SPECIAL USE PERMIT – ADDENDUM

PVT Integrated Solid Waste Management Facility Relocation Project

PVT Land Company, Ltd.
Waiʻanae District, Oʻahu, Hawaiʻi
Tax Map Key (TMK) 8-7-009:007

June 2020

Figure 2-5: Land Use

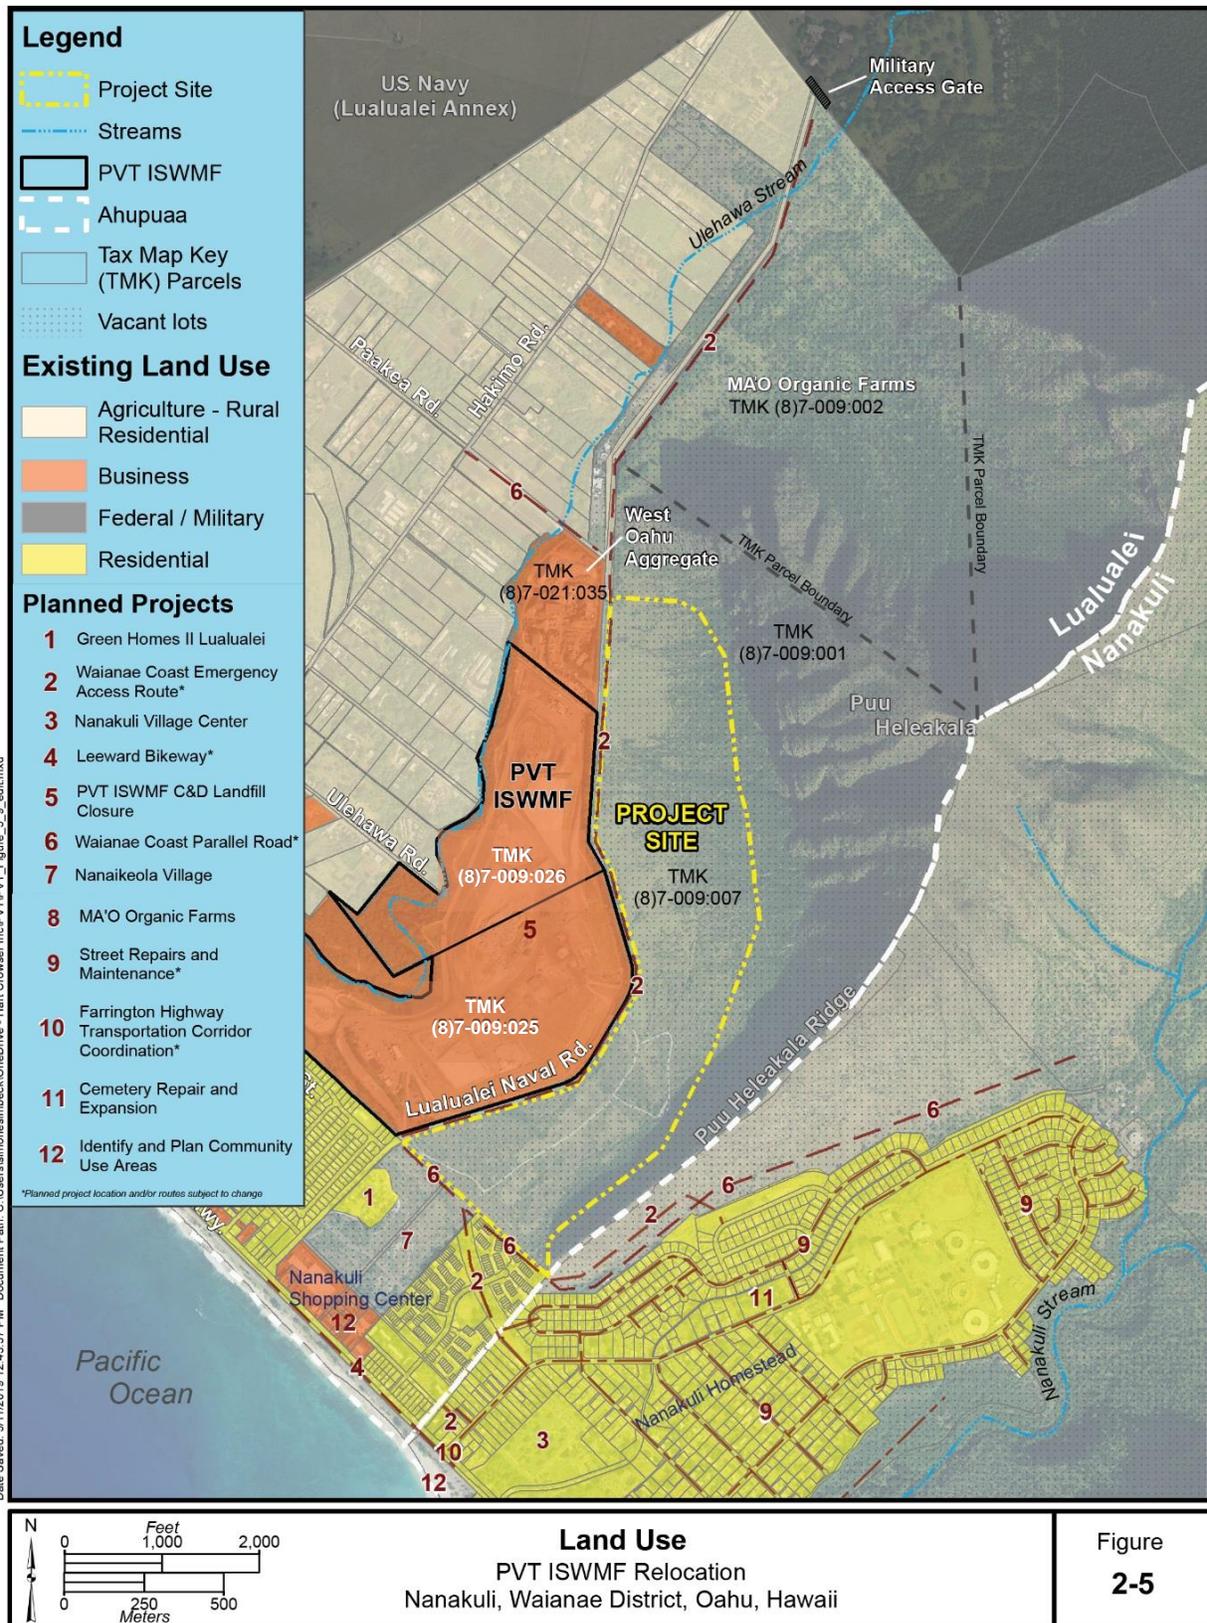
- Item #3** The TMK labels at the existing PVT ISWMF were revised on Figure 2-5 in response to DPP's request during preliminary review.

Revised 06/19/20
